UNITED STATES PATENT AND TRADEMARK OFFICE

APPLICATION NO.	FILING DATE	FIRST NAMED INVENTOR	ATTORNEY DOCKET NO.	CONFIRMATION NO.
10/034,578	12/28/2001	Bernhard Albeck	970266D2/TL	1795
1933	7590	06/01/2005	EXAMINER	
FRISHAUF, HOLTZ, GOODMAN & CHICK, PC 220 5TH AVE FL 16 NEW YORK, NY 10001-7708			LE, THANH TAM T	
			ART UNIT	PAPER NUMBER
			2839

Office Action Summary

DETAILED ACTION

FIGURE A

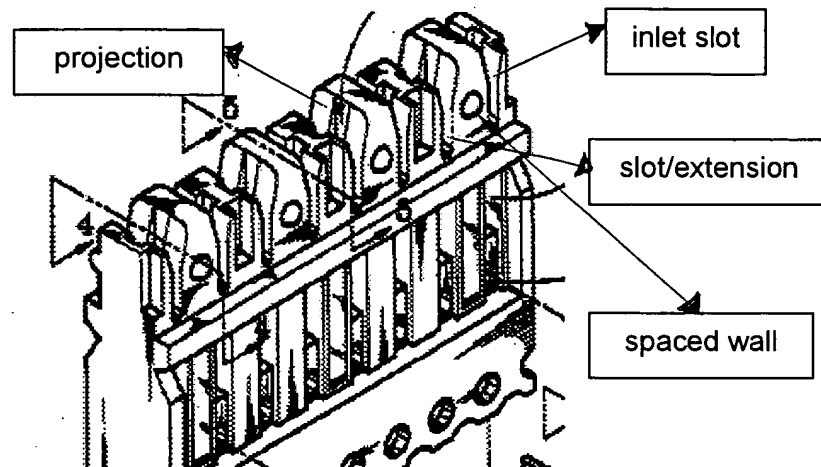
Chen, figure 2, discloses a terminal (2) comprising:

- a contacting zone (20) having an insulation piercing slit blade connector (SBIPC) (1) located therein;
- an insulating housing (4) formed with an inlet slot (a FIGURE A below) to receive a wire and retaining the SBIPC with an wire receiving slit (14) aligned with the inlet slot;

wherein the housing being formed with a slot/extension (the FIGURE A below) projecting from the inlet slot; and wherein the slot/extension, at least in part, having a width is larger than the outer diameter of the wire, including an insulation of the wire.

Regarding claim 19, figure 2, the contacting zone is formed by a pair of projections (the FIGURE A below) facing to each other, wherein the terminal is formed with spaced walls (the FIGURE A below) extending away from the SBIPC in a direction essentially perpendicular to the SBIPC, the pair of projections being integral with the walls.
